### Lockerbie PSP

#### Submission for the GAA draft Precinct Structure Plans open for public comment

**Application: 1450 Hume Highway, Kalkallo VIC**

**Application: 40 Dwyer Street Kalkallo VIC**

Figure 1: Annotated PSP plan with bicycle comments

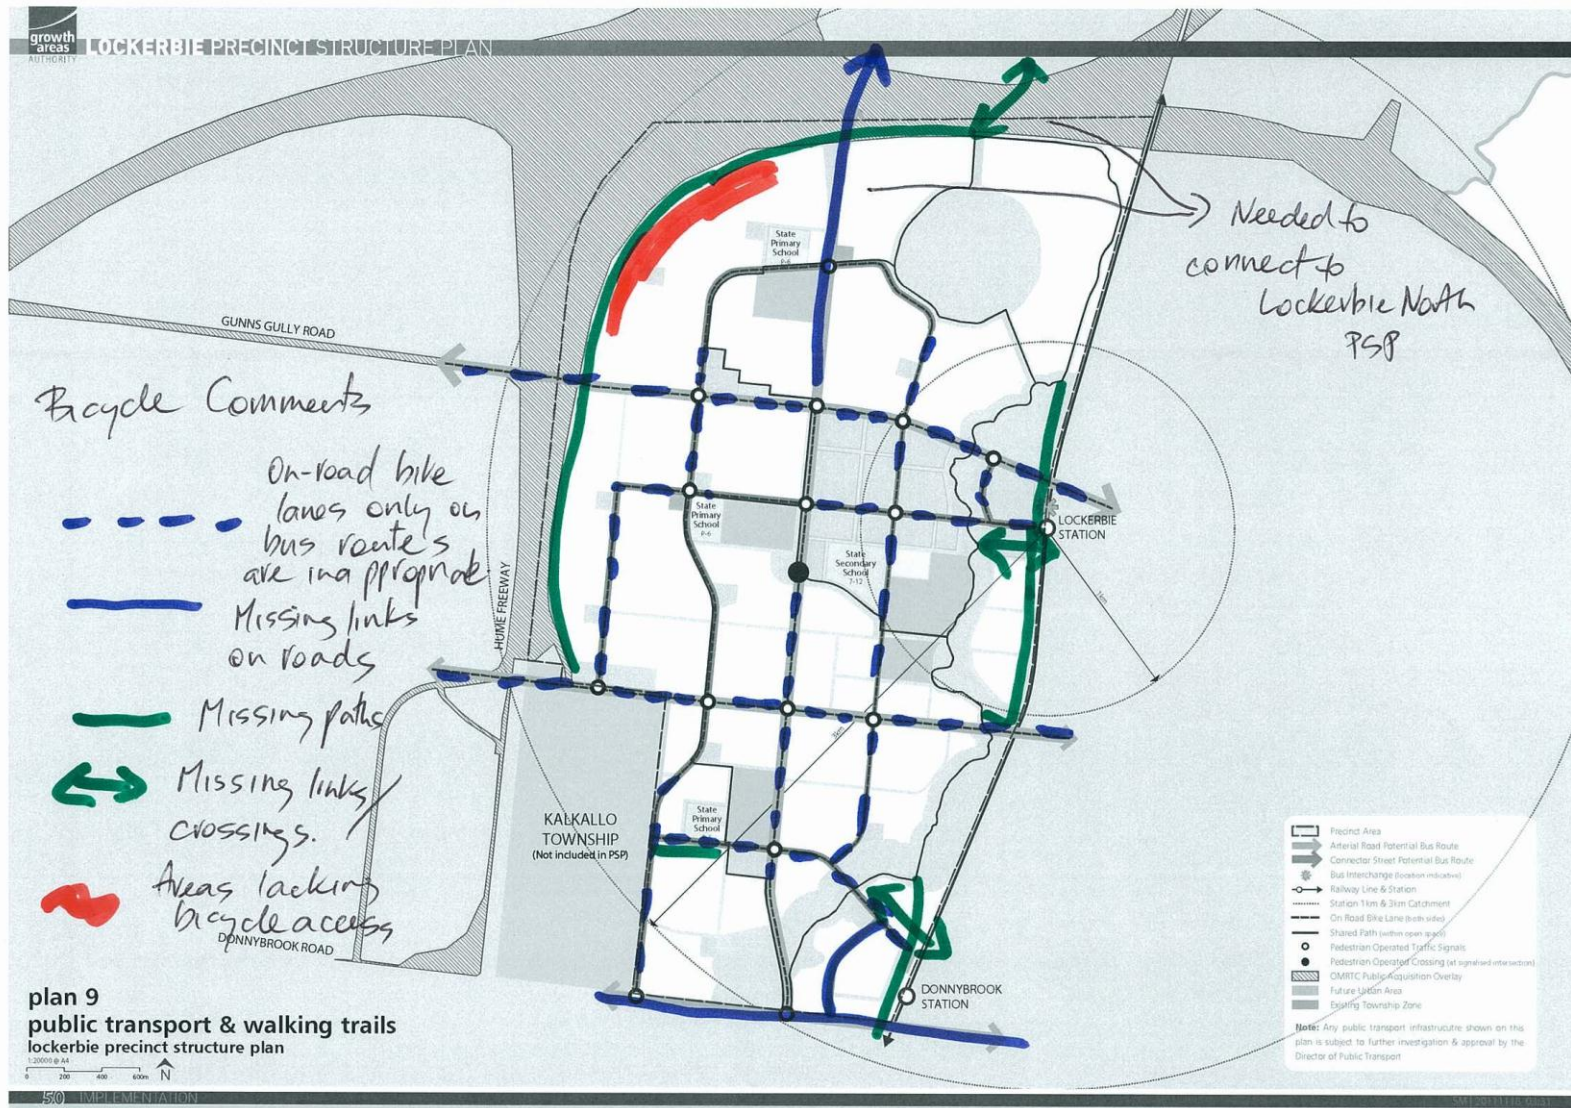
Network of bicycle routes - bicycle routes (on-road lanes and/or off-road paths) are provided along connector and arterial streets and local access streets are configured to limit speeds and volumes. This provides connectivity to most destinations, including school, parks and Local Town Centres but lack of paths along the Hume Fwy and Outer Metro Ring road mean that areas in the NW are more than 400m of a marked bicycle route. The figures on Page 23 show paths on both side of Merri Creek but these are not shown in Plan 9.

Connections to destinations – Lockerbie Township is connected via the Merri Creek off-road path and on-road lanes though an off-road bike path on High St through the town centre should be provided to allow connection to the Merri Creek path. Lockerbie Station and Donnybrook stations are isolated due to a lack of path alongside the railway line past the stations – the Merri Creek path is more than 400m from the stations at these points and a path along the railway line is needed to allow connection. The southern and northern LTC are connected via off road paths and on-road lanes.

Access into Town Centres – Detail of access for bikes within the Lockerbie Principal Town Centre show reliance on the Merri Creek shared path to the east with no marked bicycle facilities into the town centre or to local destinations. A continuous shared path or bike only path on High St from Lockerbie Station to the Local Active open space to the west with connections to the Merri Creek path would remedy this. Detail for access for bikes in the south LTC also shows the off-road shared path skirting to the south of the LTC. This path can be used for access into the centre. Detail for access for bikes in the north LTC does not show the shared path shown on Plan 9 which can be used for access into the centre.

Crossing of barriers – The Hume Freeway to the west, the railway and Merri Creek to the East and Outer Metro Ring road to the north are all potential barriers. There are no crossing points of the OMR in the north shown despite Lockerbie North PSP showing linkages south to Lockerbie. Crossings are also lacking across the Merri Creek to Donnybrook and Lockerbie Stations and then

Off-road paths - the plan does not seem to specify a minimum width for paths which should be 3m for shared paths (2.5m for local access paths) with a metre clearance on both sides to obstacles.

Connector streets with schools, parks, community facilities – most schools, parks and community facilities will be located on connector streets. These streets are likely to carry significant motor vehicle traffic volumes at moderate speeds (50-80km/h). On-road bike lanes on these roads are unlikely to be used by school children, family groups or novice riders and separated off-road paths, with clear and unhindered crossing of minor streets, are more appropriate. They also serve to connect to the wider off road path network alongside parks and green corridors. Most connector streets in the plan area propose on-road lanes and many also have parallel shared paths especially past schools. The exception is the eastern north south connector which passes the State Secondary school and community facility and the southern connector street which links Kalkallo township to Donnybrook station via the southern LTC and Primary School. This impacts planning permit application P15826-96A – see below.

Connector streets with buses and bikes - Many of the connector streets have marked on-road bike lanes on potential bus routes. This may lead to conflict between buses and bikes as buses must cross and recross the bike lane to load and unload passengers. Off-road bike paths are more appropriate on these routes as bicycles can run behind stops and high frequency bus services will not be hindered in their operation. Off –road bike paths also mean a narrower paved road width which is easier for pedestrians and potential bus passengers to cross. One connector street in the south eastern corner has no bicycle facility indicated.

Bike lanes on high speed roads – Stewart St, Green Gully Road and the central east west arterial and Donnybrook Road are higher speed arterial roads which propose on-road bike lanes alongside motor vehicles travelling above 70-80km/h. Austroads Guides to Road Design (2009, 2011) recommend separated bike paths for these traffic regimes and these are much more likely to be used by less confident and novice bike riders such as children and family groups who do the majority of riding in the community via short trips to school, shops and friend and for recreation. Separated, bike only paths are more appropriate for these roads but care needs to be taken to design intersections and cross overs (driveways etc.) to provide clear and unhindered passage for bike riders. A bike path that stops and gives way at minor intersections does not properly provide or encourage bike riding. Stewart St, Green Gully Road and the central east west arterial are especially important as they provide direct connections from north to south and east to west past several schools and parklands and into Lockerbie and Kalkallo townships. The northern end of Stewart St and the southern arterial do not have any bicycle facility indicated in Plan 9.

riders and walkers mean both are disadvantaged. This can discourage walking and cycling; especially by the more vulnerable who may be fearful of venturing onto a busy shared space. Widening of the path only works up to a certain point and then it makes more sense to provide separated bike and pedestrian paths. Experience and modelling has shown that where peak bicycle volumes exceed 200 bikes per hour with more than 100 pedestrians per hour then separate bike and pedestrian paths are appropriate. The links from Lockerbie Station into Lockerbie Township and past the schools as well as the link from Donnybrook Station to Kalkallo Township past the Primary School would be candidates for separate bike paths.

Undercover bicycle parking at public transport hubs – many local trips can be made by bike but longer trips using a bicycle, especially to distant workplaces and tertiary education, rely upon connections to public transport and leaving in a secure place for the day. The current Parkiteer cages at train stations are an example of secure, undercover bicycle parking that allows people to ride to the station and leave their bike. Similar facilities should be provided where public transport connections for bike riders are expected. Lockerbie and Donnybrook Stations should have such facilities.

Figure 2: Annotated Permit application plan P 15826 with bicycle comments.

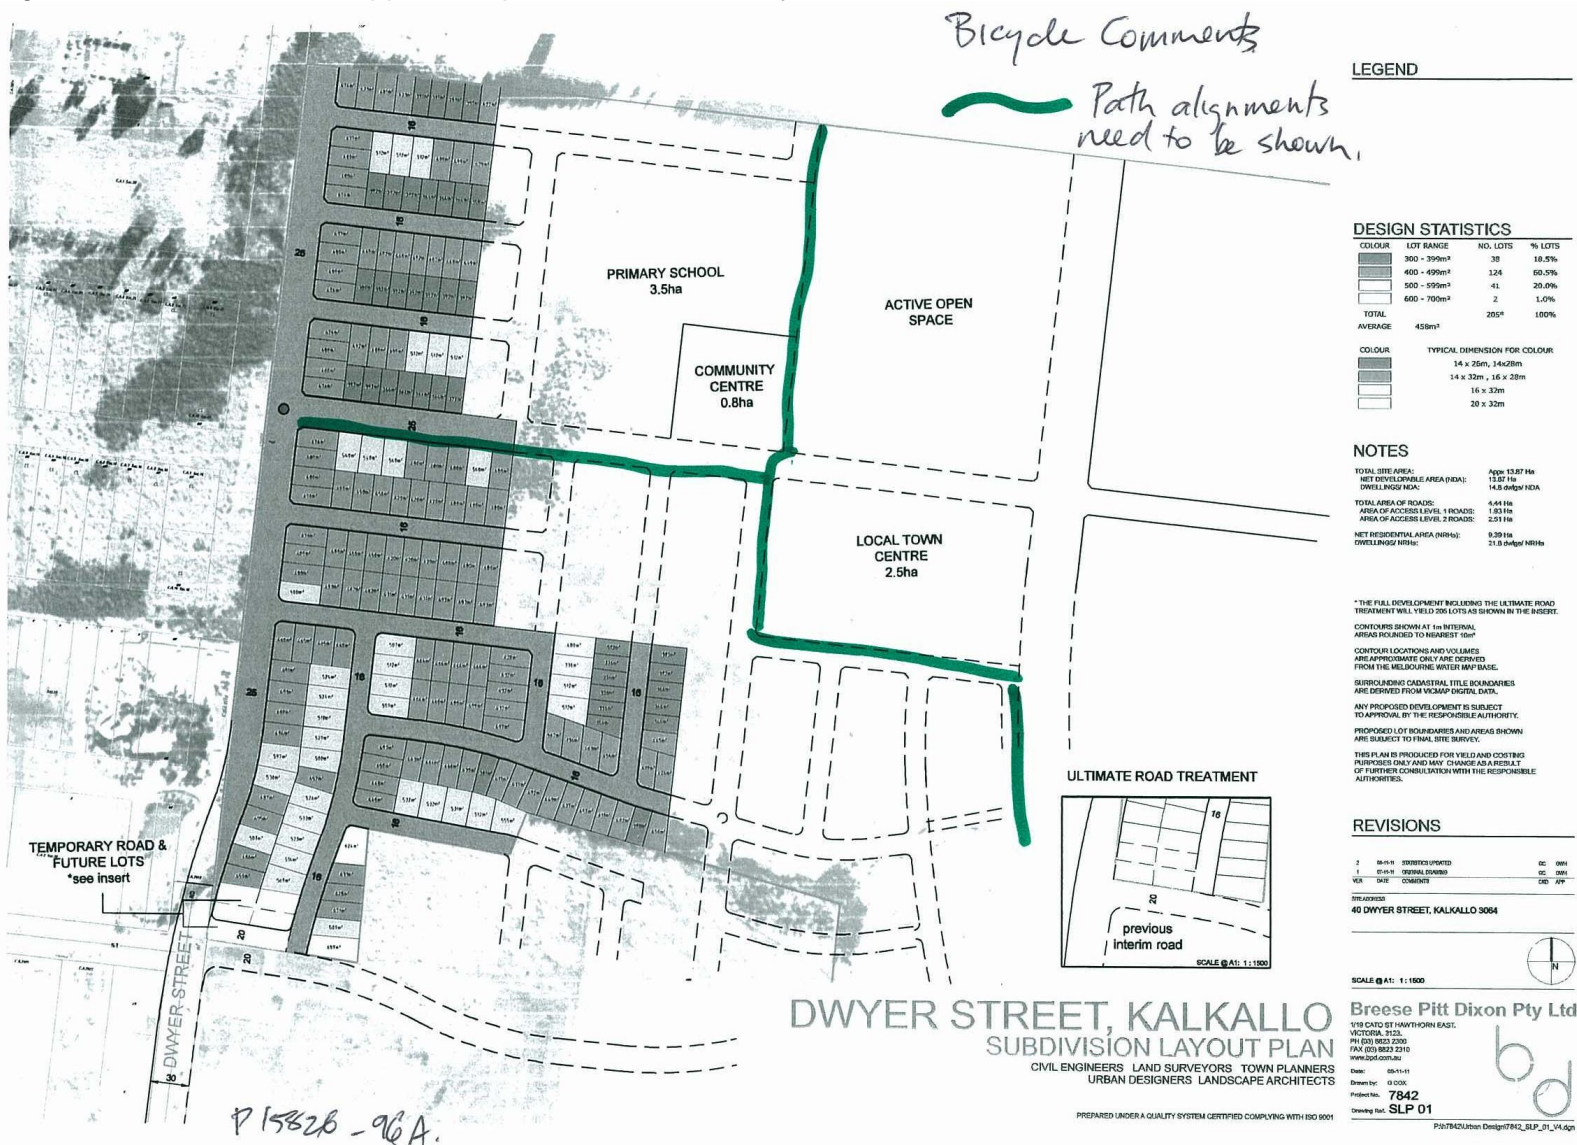
The application applies to land to the east of Kalkallo township and lies on the connector street which connect Kalkallo to Donnybrook Station. The PSP shows an off road path alongside the school and to the south of the LTC. This alignment is not shown on the application plan. Also comments provided above recommend an off-road path on the connector street past the primary school and community centre to the LTC. This is not shown on the application plans. These recommendations are shown in Figure 2 attached.
